Work Order ID 83477

Item Name: Basket Hoop

DESIGN #	DRAWN BY CP	DART AEROSPACE LTD HAWKESBURY, ONTARIO, CANADA	
CHECKED #	APPROVED #	DRAWING NO. D3166	REV. A SHEET 1 OF 1
DATE 02.07.10		TITLE BASKET HOOP	SCALE NTS
A	02.07.10	NEW ISSUE	
A1	04.04.08	38+/-1 WAS 36.0

DRAWING NO. D3166	TITLE BASKET HOOP	REV A1	DART AEROSPACE LTD ENGINEERING ORDER		D.E.O. NO. D3166-A-2	SHEET NO. 1 OF 1	SCALE NTS
DRAWN AJS	CHECKED 1	MFG. APPR. M	APPROVED MP		DE APPR. H		
DATE 08.12.11	DATE 08.12.15	DATE 08/12/15	DATE 08/12/16		DATE 08.12.16

D3166-1 BASKET HOOP

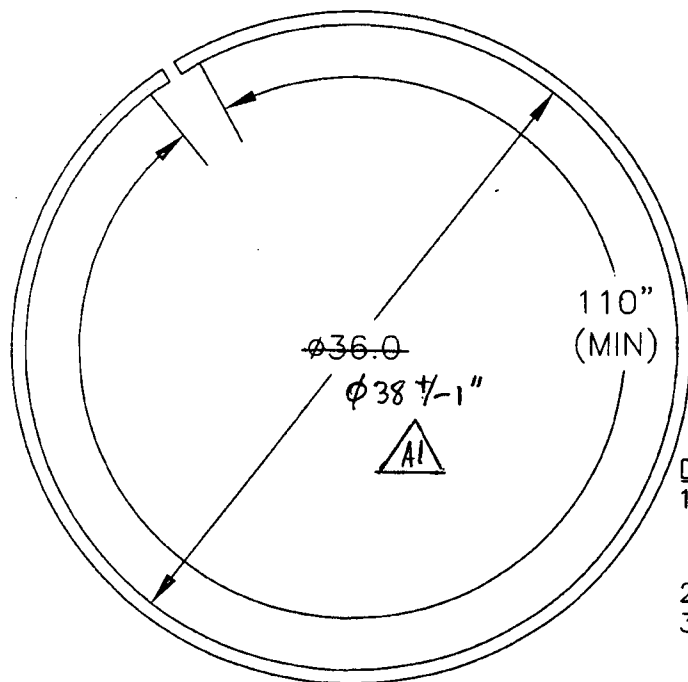
1) MODIFY MATERIAL NOTE FOR D3166-1 AS SHOWN:

WAS:

1) MATERIAL: AISI 304/316 SS SQUARE TUBING,
0.75" x 0.75" x 0.063 WALL, 60.00" LONG
(REF DART SPEC. M304TS0.750W.063)

IS:

1) MATERIAL: AISI 304/316 SS, 3/4 X 3/4 X 0.065 WALL SQUARE TUBING,
60.00" LONG
REF. DART SPEC M304TS0.750W.065
